Gary Hunt Investments Pty Ltd  
ACN 627 072 584

CEO  
Douglas Shire Council

Attn: Neil Beck  
Ref: CA 2021\_4239/1 (1028000)

INFORMATION REQUEST  
(Given under Section 12 of the Development Assessment Rules)

HYDRAULIC SERVICES MASTER PLAN SEWER RISING MAIN		
PROJECT NO.	DRAWING NO.	REVISION
20124	SK03	1

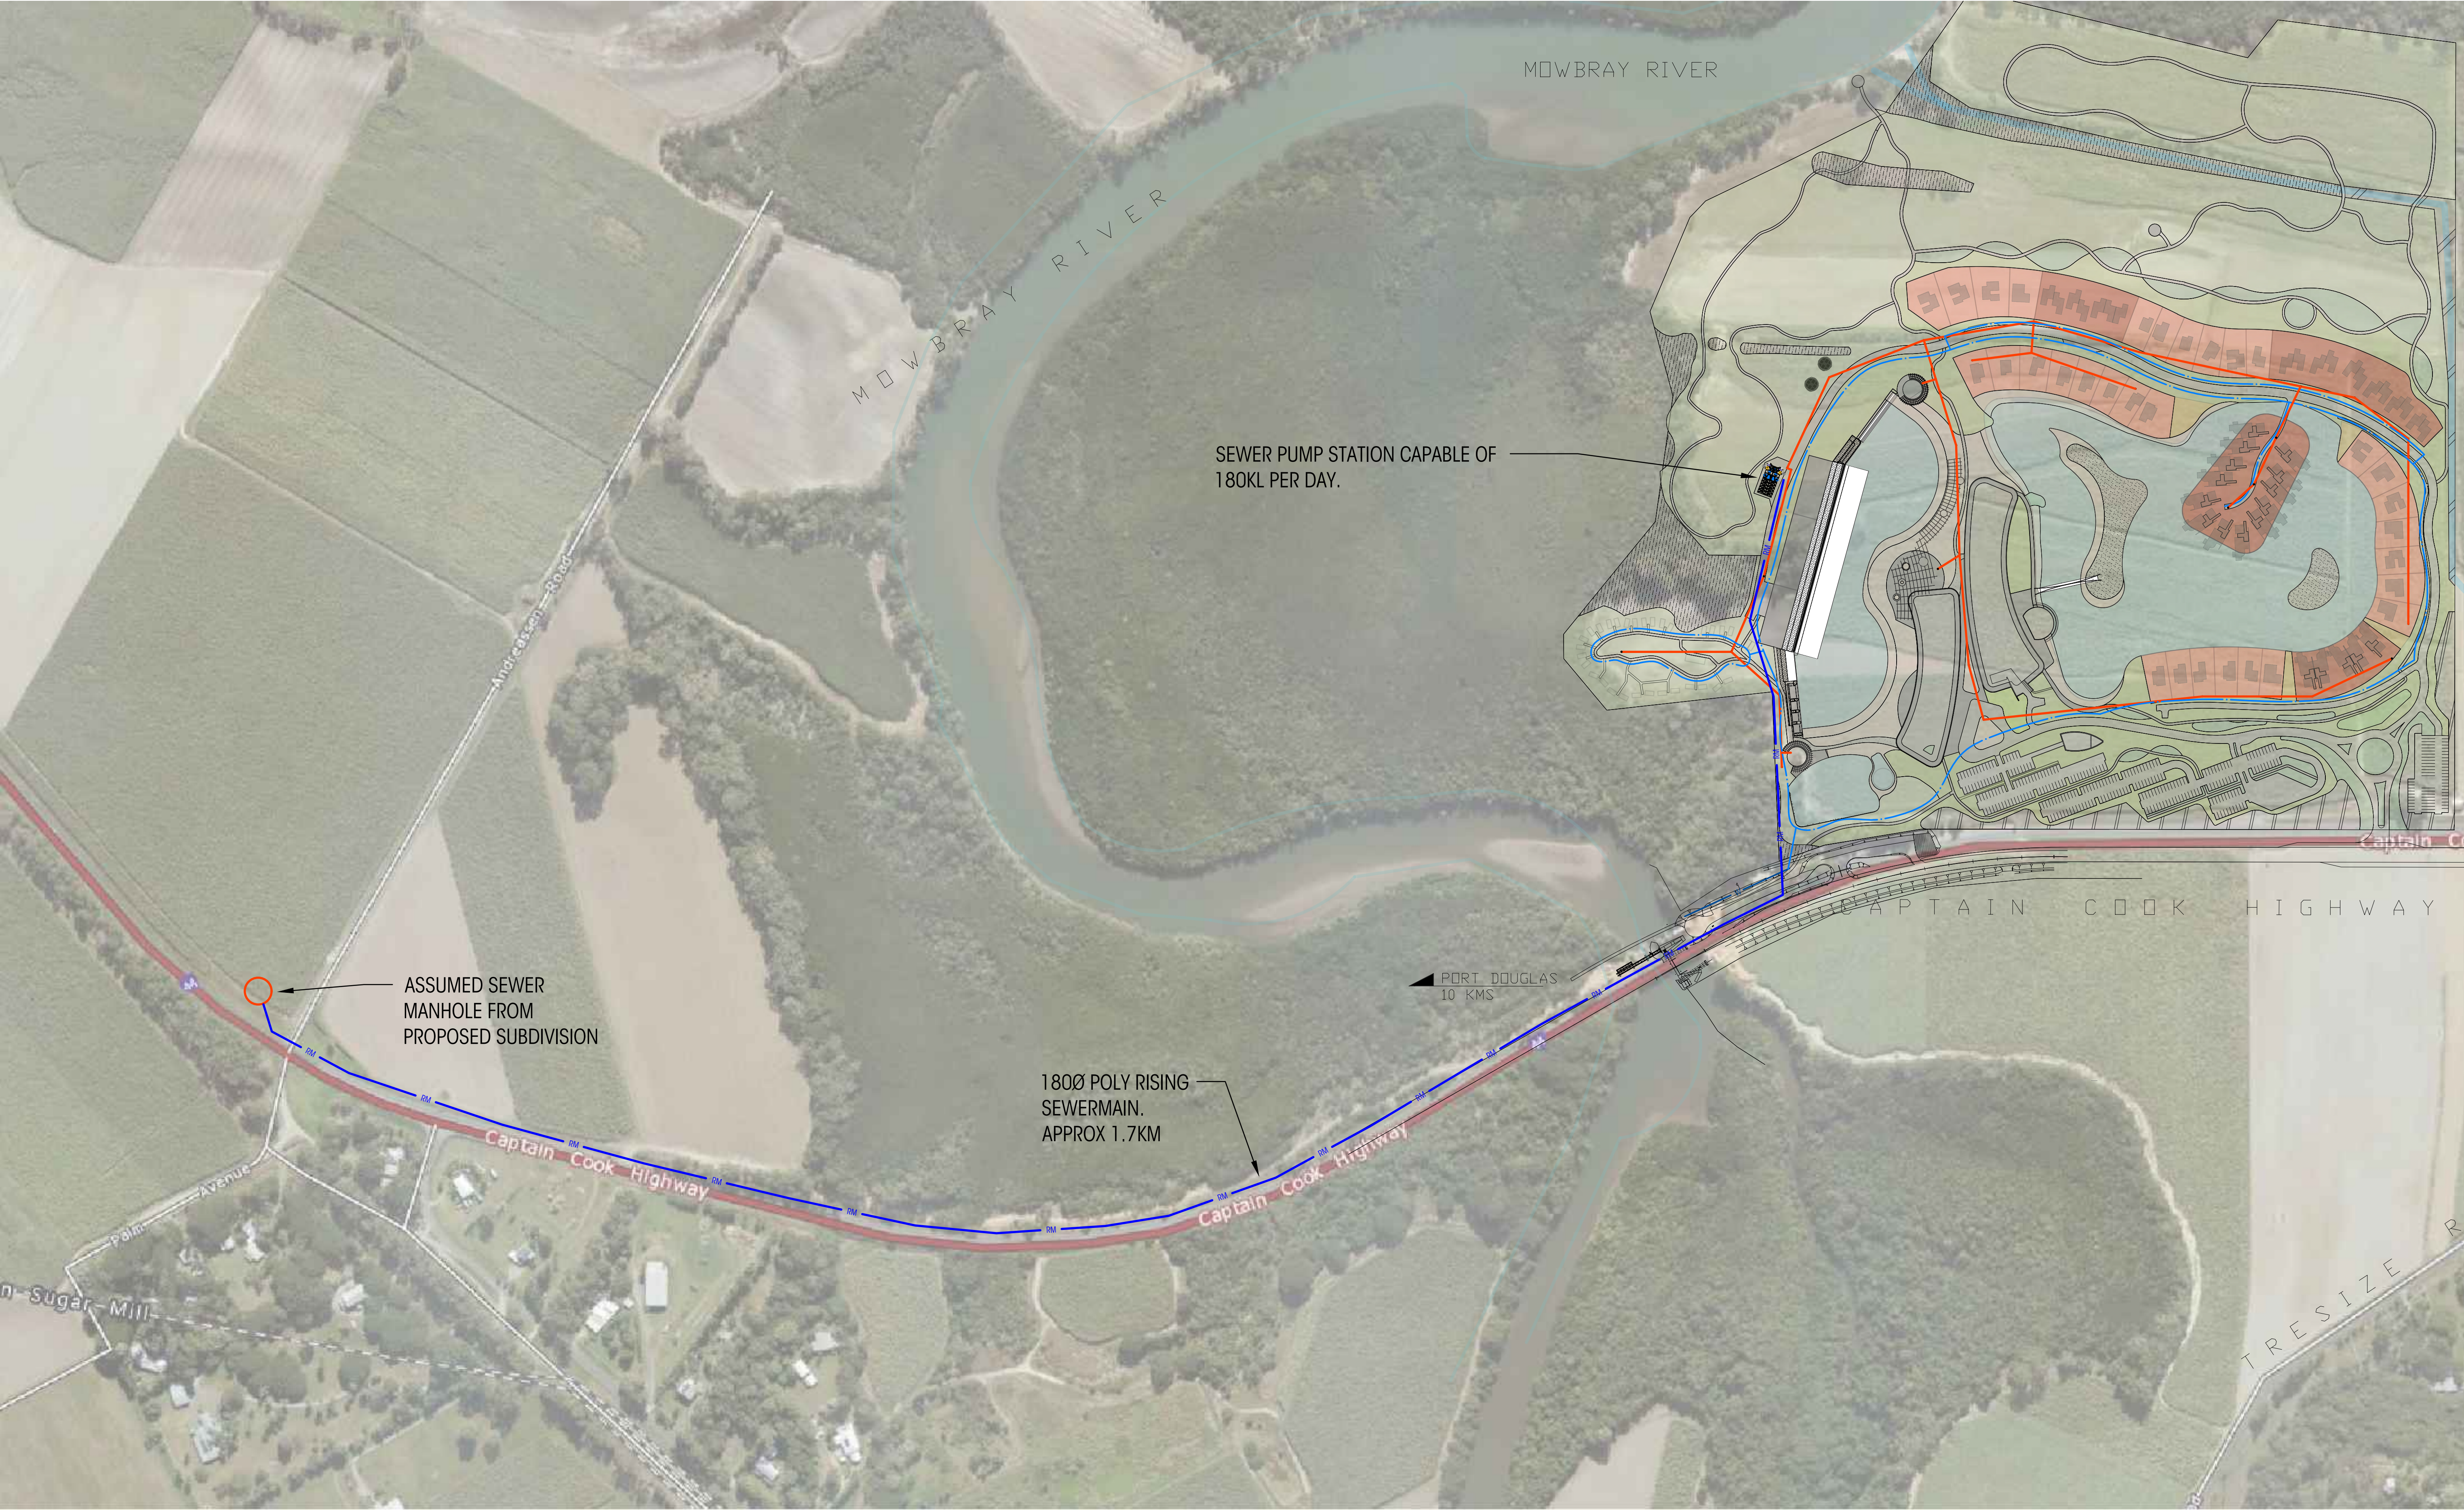
11. Provide sewage demand calculations for the sewage loads generated from each element of the development. The demands must be in accordance with FNQROC unless substantiated by appropriate detailed studies. Some of this work may be conditioned for later stages, however, appropriate clarity must be provided now to determine how the development will be connected to Council's reticulated network and the additional demand placed on the sewerage treatment plant. It is proposed to connect the Development to the Council sewer infrastructure at the new proposed Development on the corner of the Captain Cook Highway and Andreassen Road.

The proposed sewer infrastructure internally of the Development is for a vacuum system, discharging to a Development Sewerage Pumping Station. Preliminary calculations indicate a 180mm poly (150mm UPVC) sewer rising main would run parallel to the Highway. The receiving manhole would require a 225mm Gravity Sewer connection. Further modelling would be required for the discharging sewer system. The Development Pump Station could be timed for the discharging into the council sewer network to happen outside peak times to alleviate any possible issues.
